# INDIANA DEPARTMENT OF NATURAL RESOURCES CROSLEY FISH AND WILDLIFE AREA DAM IMPROVEMENTS PROJECT

PROJECT NO. ENG1802321631/E020098

PLANS FOR PROJECT RE-BID  
SEPTEMBER 27, 2018

REVISIONS				
No.	DATE	DESCRIPTION	REVISED BY	DOF
1	9/27/2018	REVISE PROJECT ALTERNATES FOR RE-BID

DAM CROSS SECTIONS - LINE 'A'

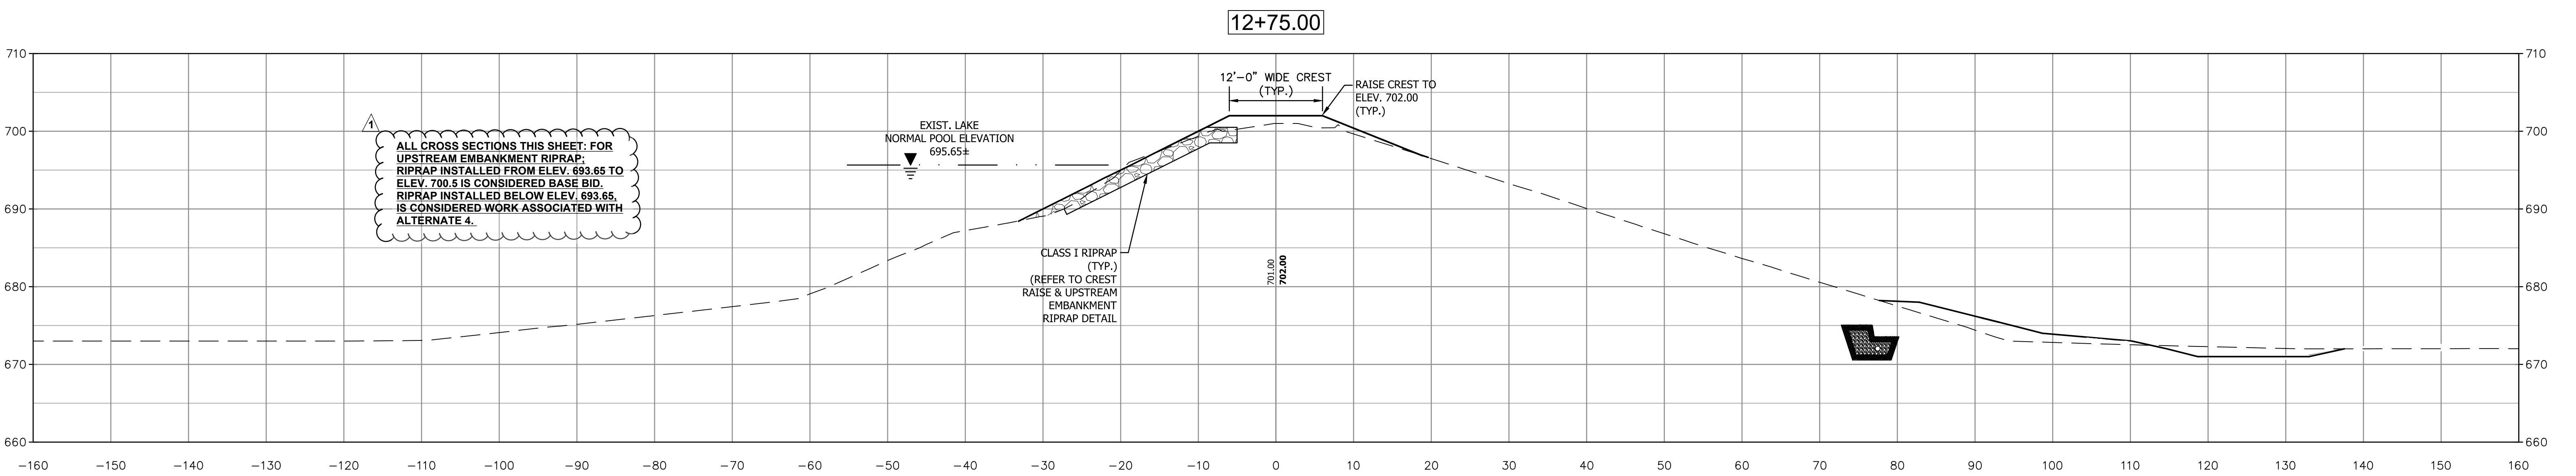
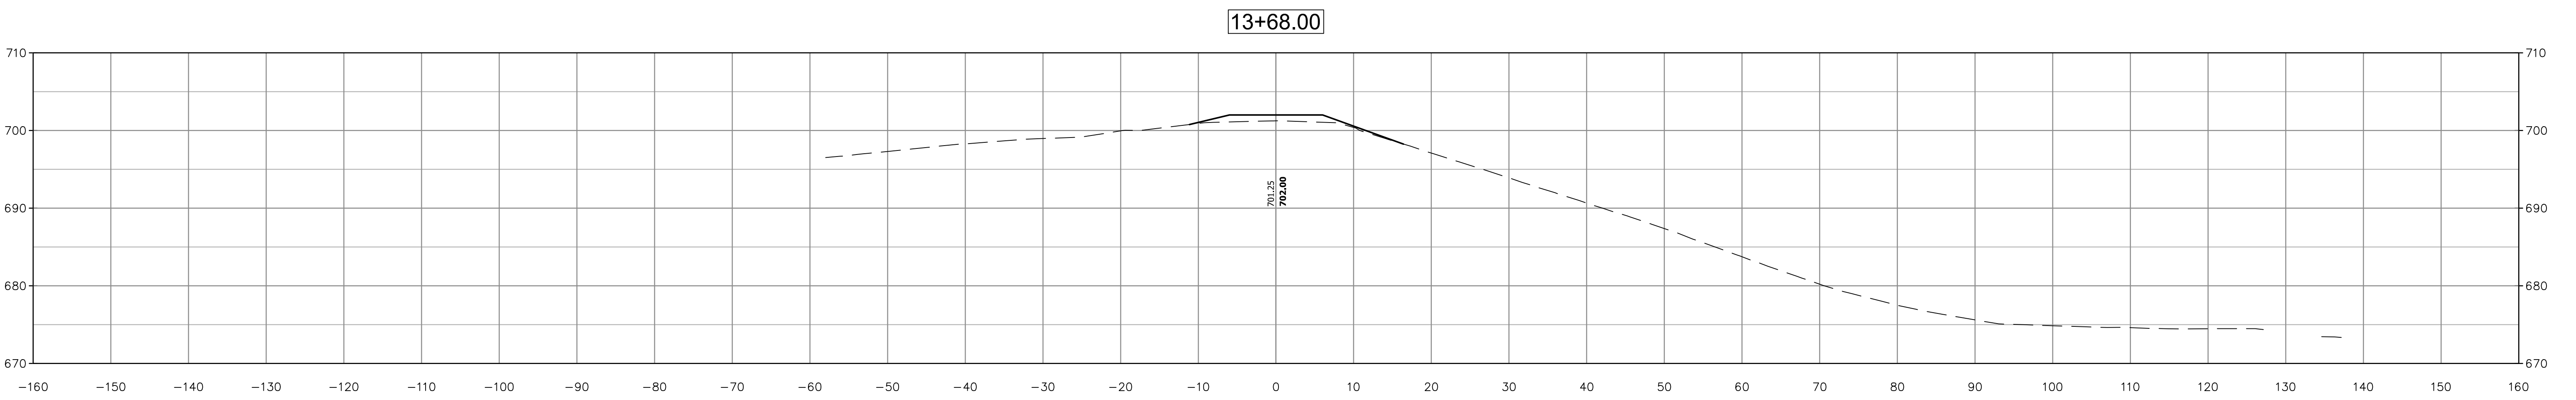
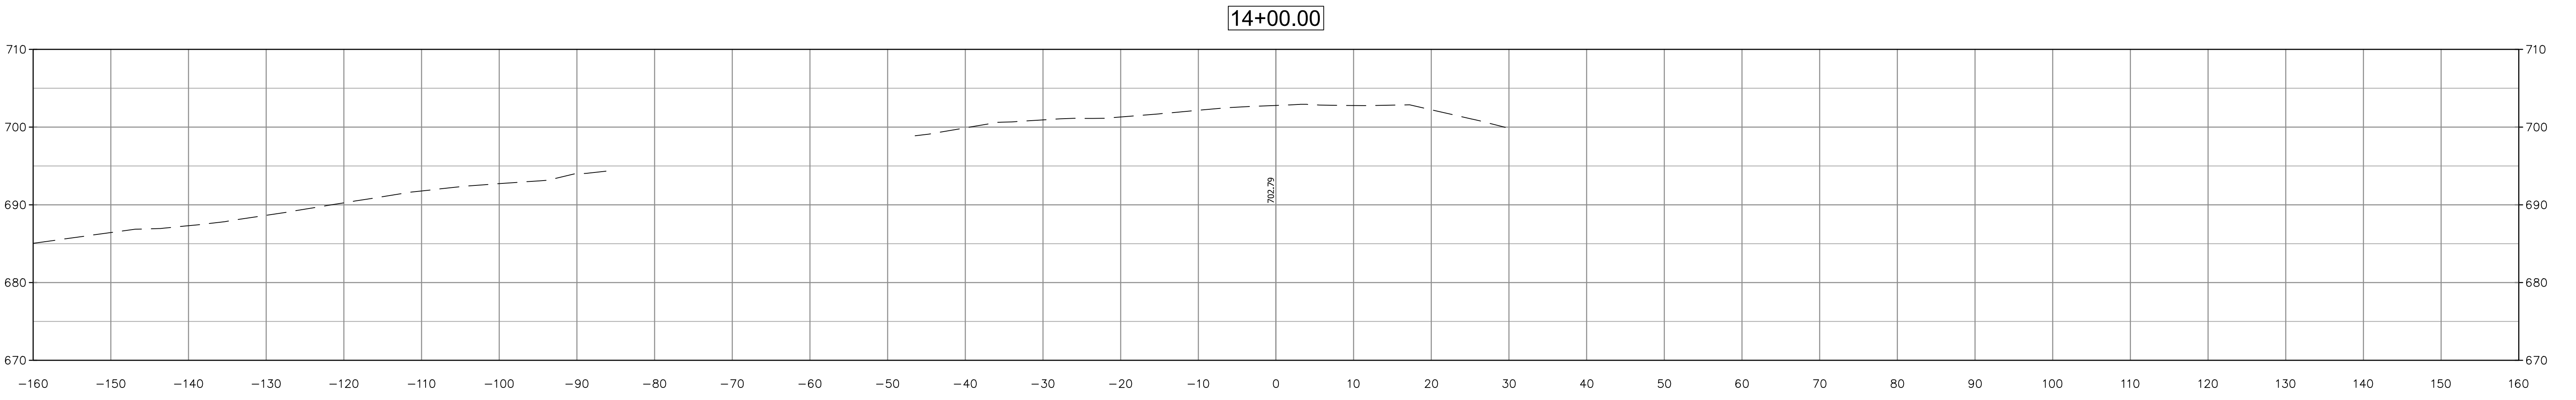
ALL CROSS SECTIONS THIS SHEET: FOR UPSTREAM EMBANKMENT RIPRAP: RIPRAP INSTALLED FROM ELEV. 693.65 TO ELEV. 700.5 IS CONSIDERED BASE BID. RIPRAP INSTALLED BELOW ELEV. 693.65, IS CONSIDERED WORK ASSOCIATED WITH ALTERNATE 4.

REVISIONS			
No.	DATE	DESCRIPTION	REVISED BY
1	9/27/2018	ALTERNATE 4 - UPSTREAM RIPRAP BELOW EL. 693.65	DOF
